ADDENDUM NO. 2

RE: **ATHLETICS DEPARTMENT
University of Wisconsin – Whitewater
Whitewater, Wisconsin**

UWSA Project No.: **N-24-001**

UW-WHITWATER - MILLER
 STADIUM PRESSBOX
 University of Wisconsin-Whitewater
 Whitewater, WI
 Sheet Title:
 FLOOR PLANS - PRESSBOX

UWSA Number: N-24-001
 KS Number: 224025.00
 Set Type: BID SET
 Date Issued: 08/26/2024
 Sheet Number: A100

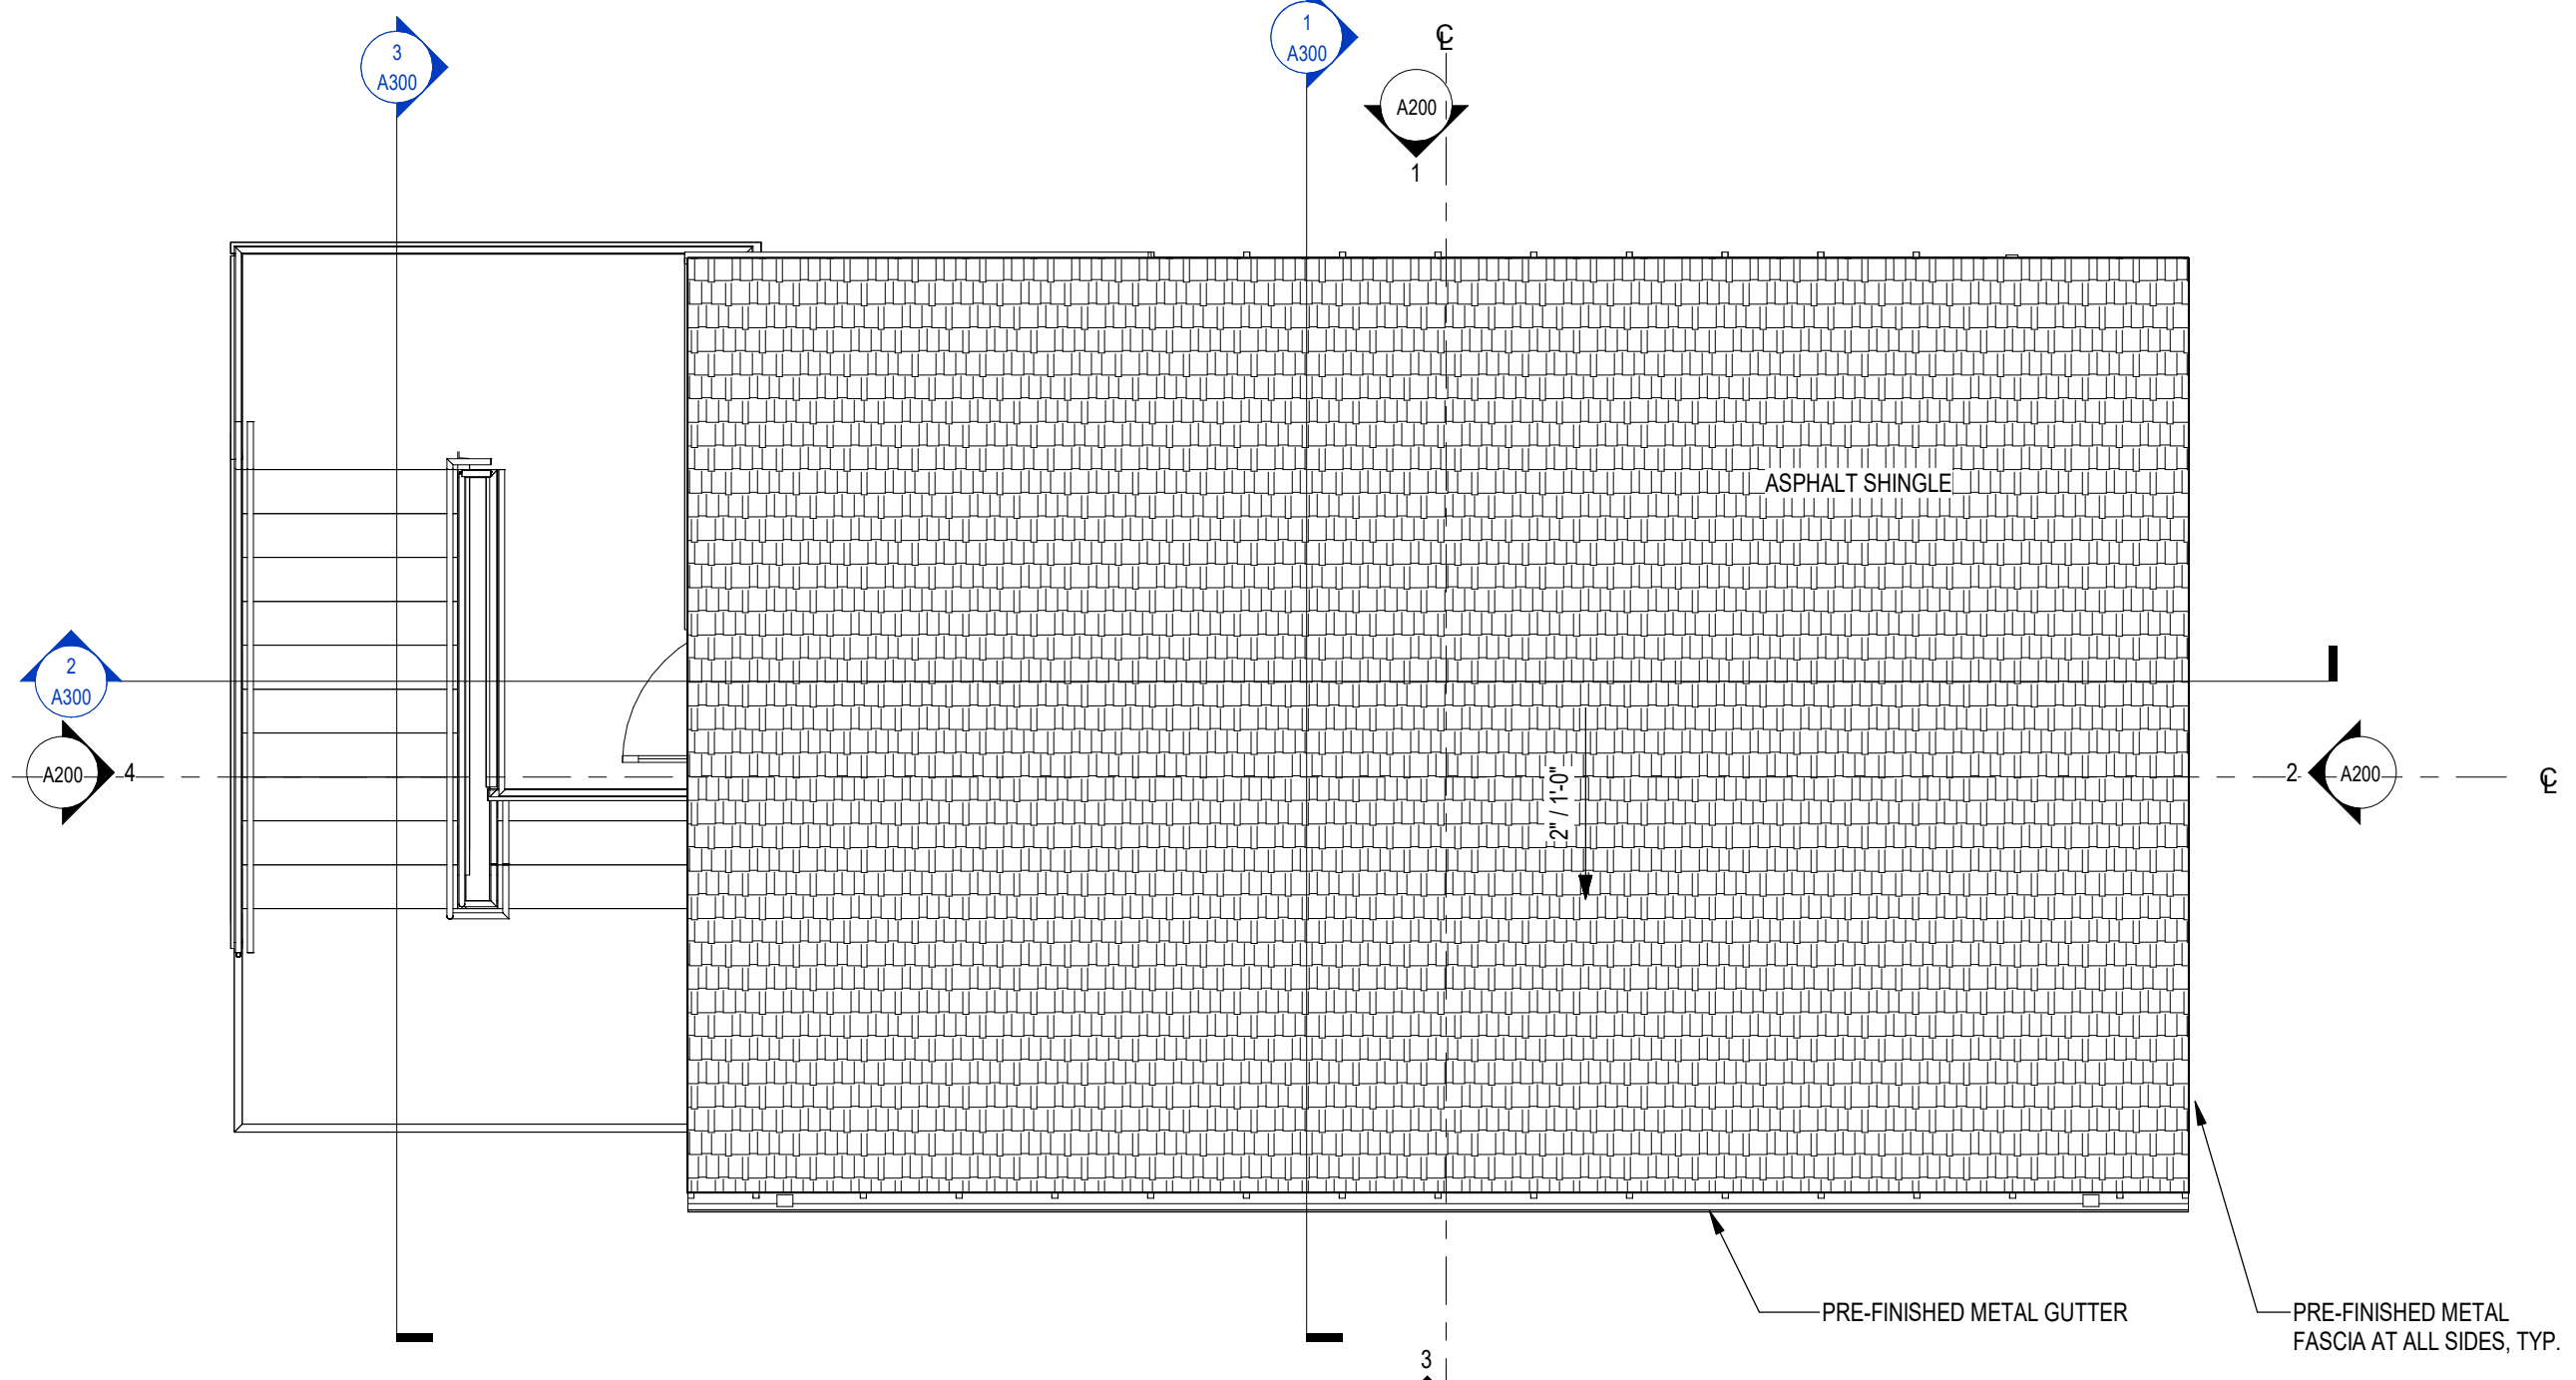
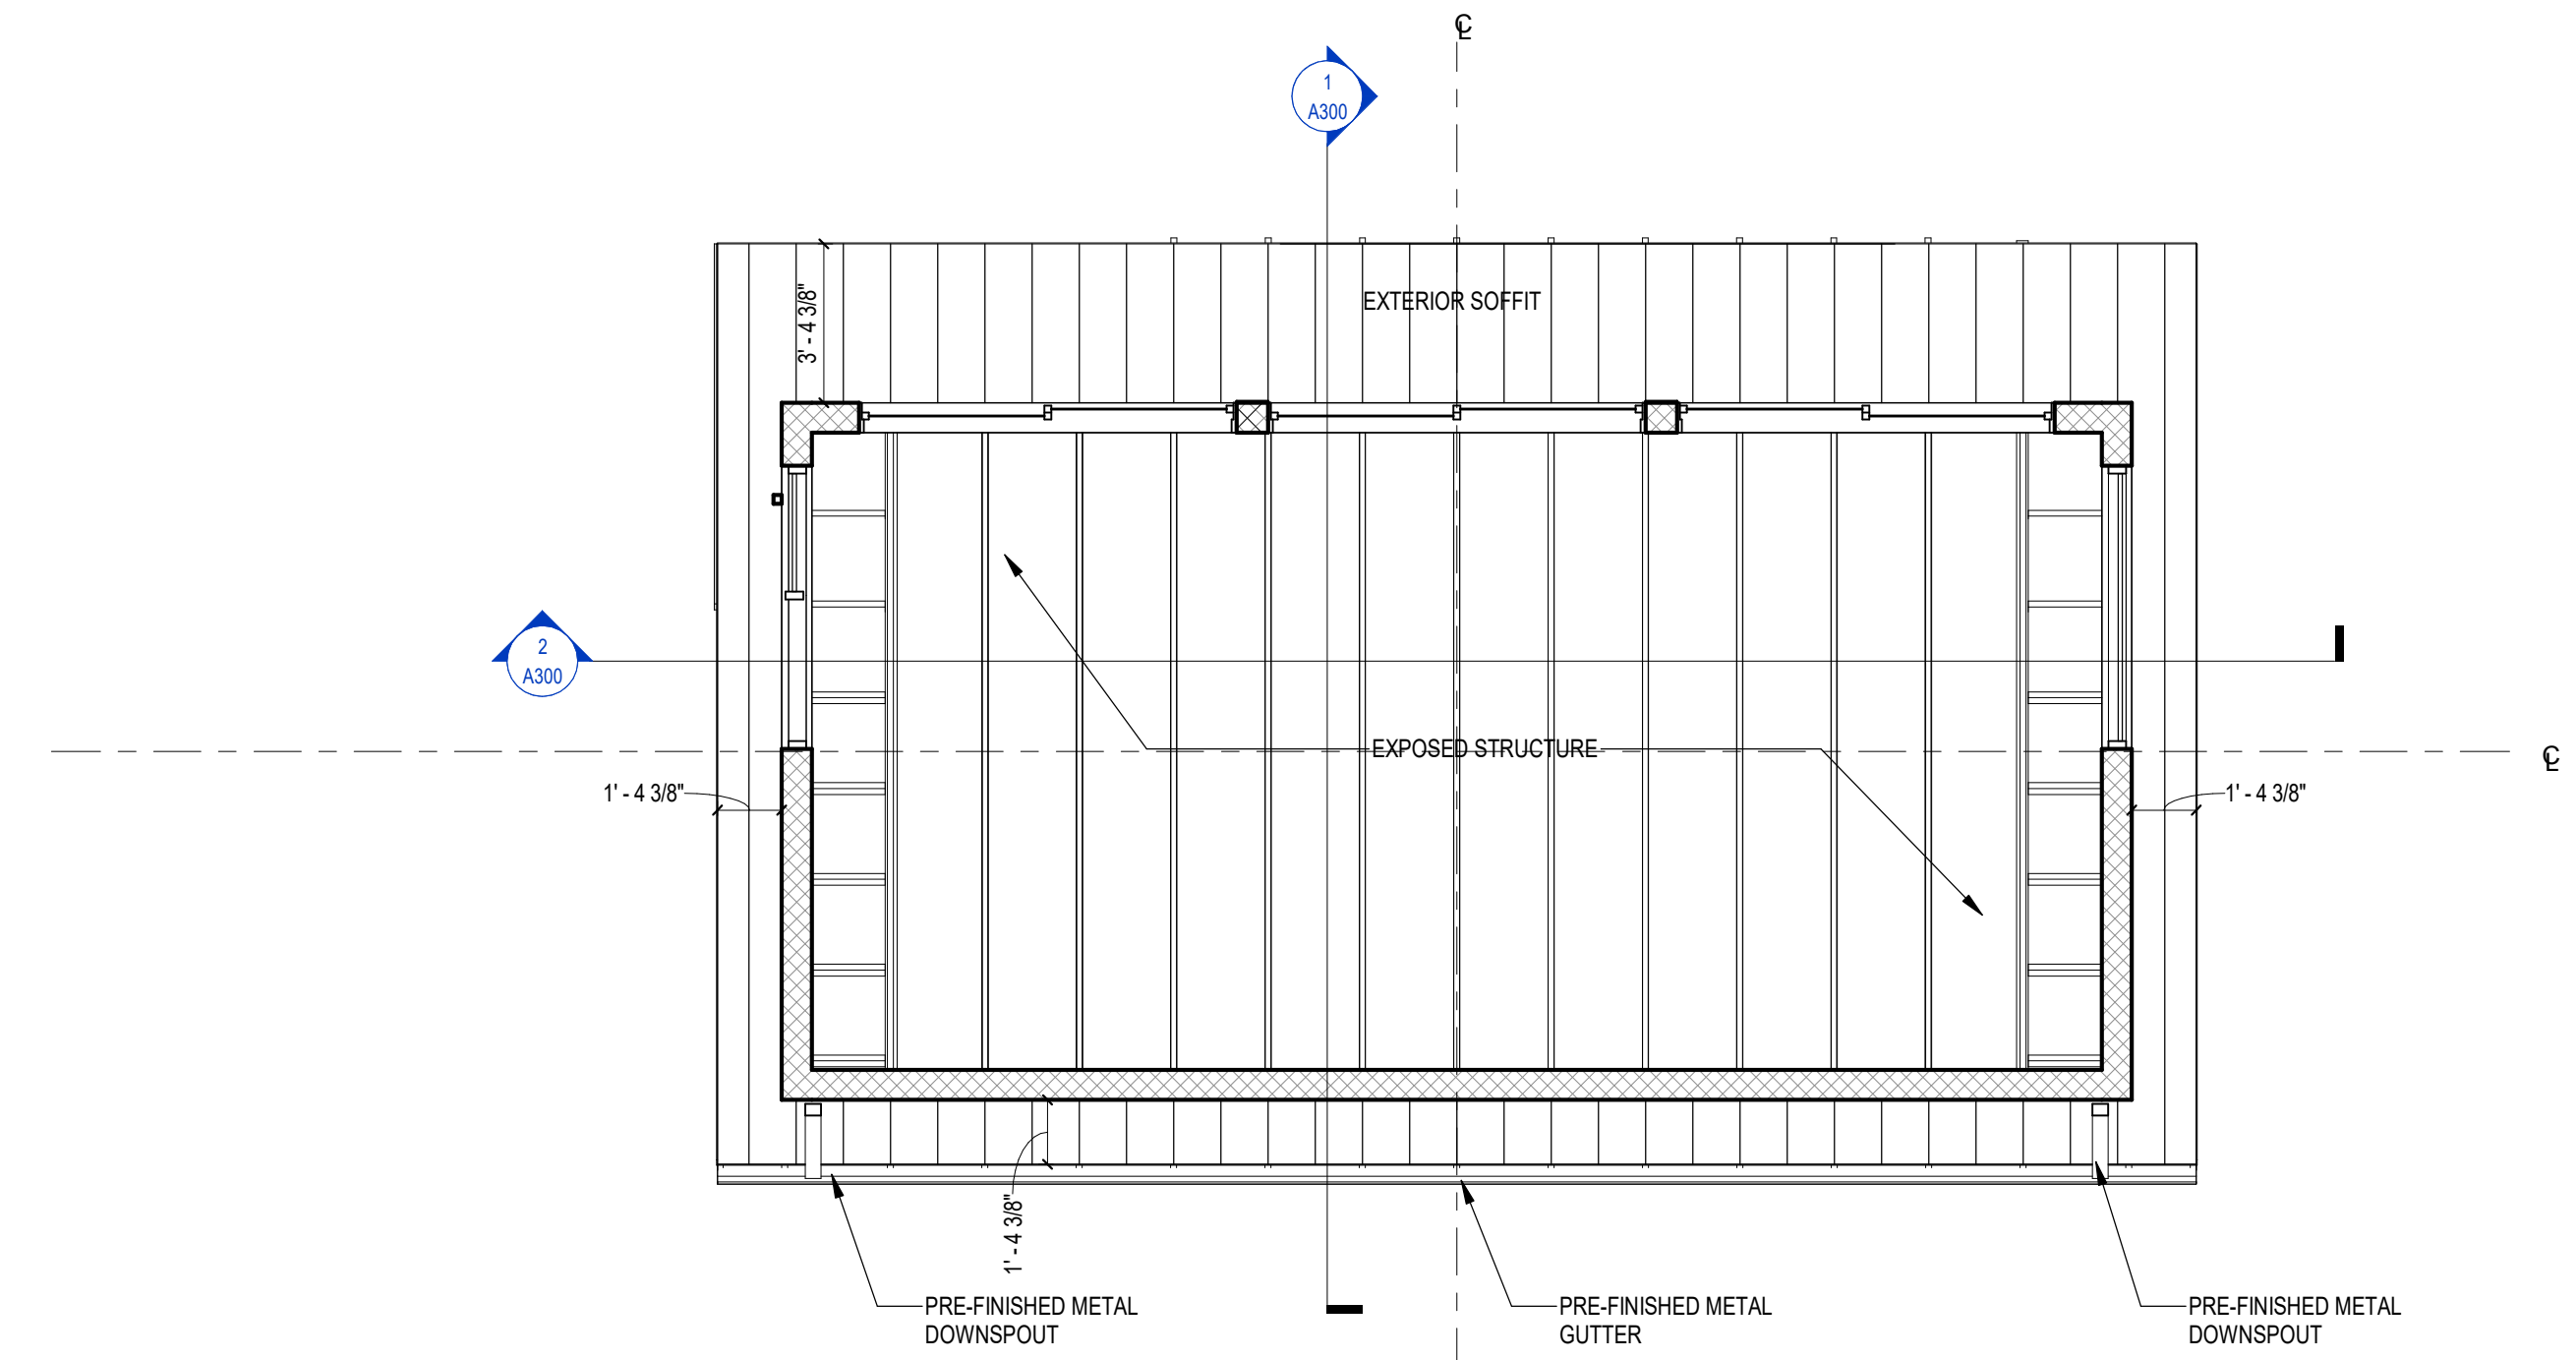
1. Sheet G002 – SPECIFICATIONS
 - a. Replace entire document with attached sheet G002
 - i. Section 08 33 13 – Overhead Counter Doors
 1. Removed lines J. and L.
 2. Revised section “N. Exterior Door Finish”.
 - ii. Section 08 71 00 – Door Hardware
 1. Added section “H. PRODUCTS”
2. Sheet A100 – FLOOR PLANS-PRESSBOX
 - a. Replace entire document with attached sheet A100
 - i. Added notes to door schedule.
3. Sheet A200 – EXTERIOR ELEVATIONS
 - a. Replace entire document with attached sheet A200
 - i. Revised glazing elevation dimensions and added notes.
4. Sheet A500 – DETAILS
 - a. Replace entire document with attached sheet A500
 - i. Revised framing size and insulation note 10/A500.
 - ii. Removed burnished block note 29/A500.
